S E R V I C E N O T E

**4338A Milliohmeter**

**Modification prevents blowing A2F1 fuse caused by a short circuit in the A4 keyboard assembly**

Figure 1

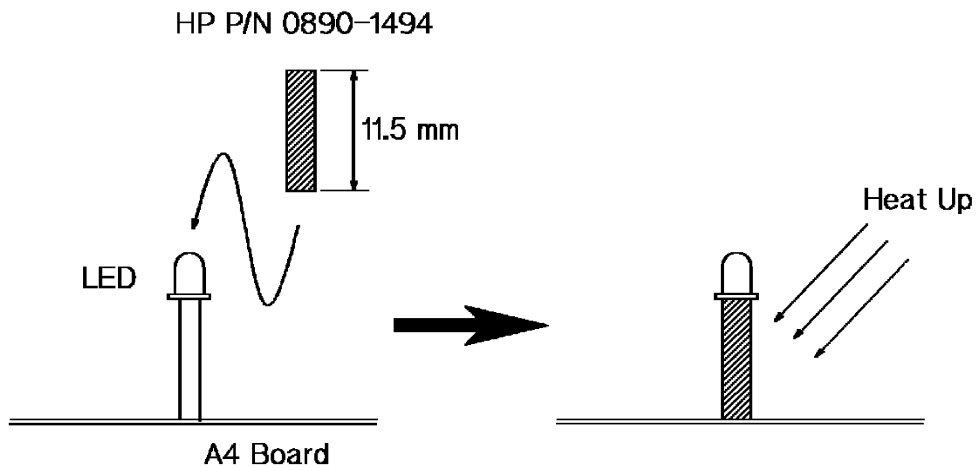
If a pin of the LED on A4 board contacts the conductive coating on the inside of the front frame, the A2F1 fuse will blow and the display will not function.

If the display doesn't function, check and replace the A2F1 fuse and take the following countermeasures. (See Figure 1.)

1. Cut the heat shrinkable tube (P/N 0890-1494) by 11.5 mm and attach it onto the LED pins.
2. Shrink the tube by heating it up.

Figure 2. LED Location

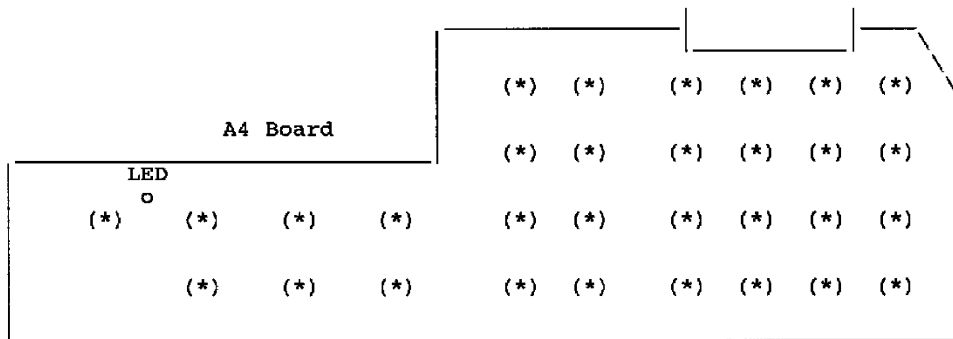
Figure 2 shows the location of the LED.
